## Determination 2019/007

# The refusal of a code compliance certificate for 18-year-old additions and alterations to a house at 26 Day Dawn Crescent, Omaha, Auckland

**Figure 2: Approximate site plan**

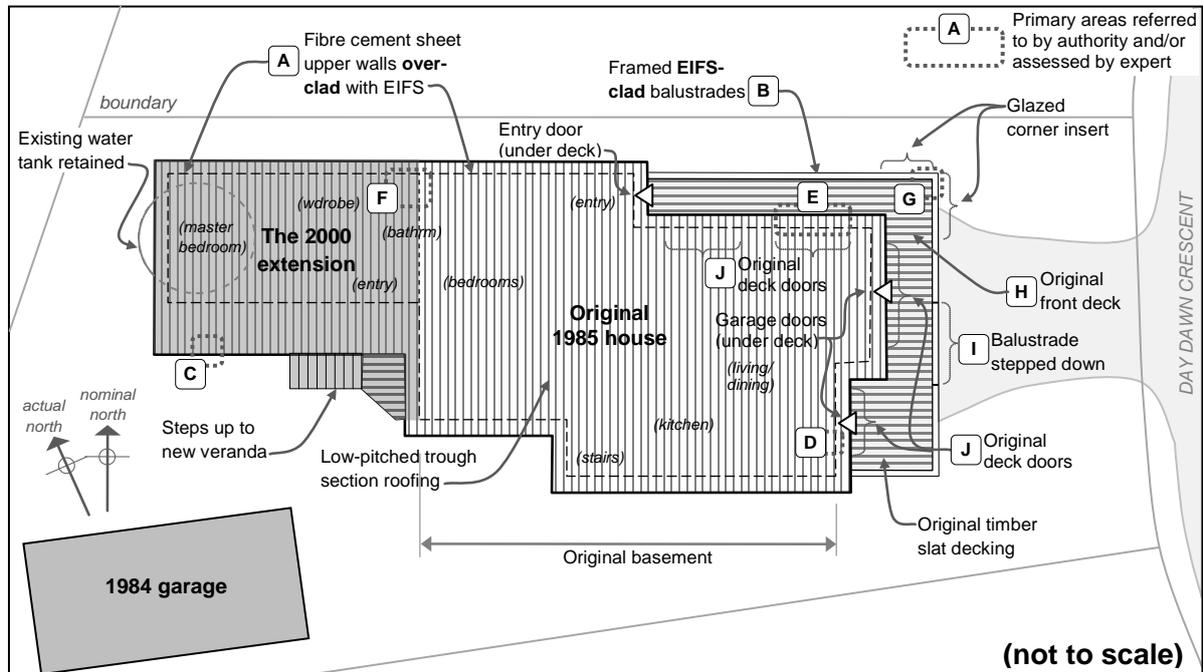
- 4.2.3 The expert removed small sections of cladding or lining at sample locations to observe the underlying construction to the following areas (see Figure 2):

4.4.1 In regard to the clad balustrade to the original front deck, the expert noted (Area B):

Section 95A notice dated 9 February 2018 (in summary)		Fig.2 Area	Comments	Para-graph	Compliance
1a)	Extension over clad	A	<ul style="list-style-type: none"> <li>• No evidence of current or past moisture penetration.</li> <li>• Wall cladding has performed for more than 15 years.</li> </ul>	4.3.1	Compliant
2a)	Smoke alarm location		<ul style="list-style-type: none"> <li>• Smoke detectors not required by the Building Code at the time of the consent was issued.</li> <li>• Several detectors located within dead air zones – contrary to current requirements.</li> </ul>	4.3.2	Cannot be enforced as a requirement of the consented work.
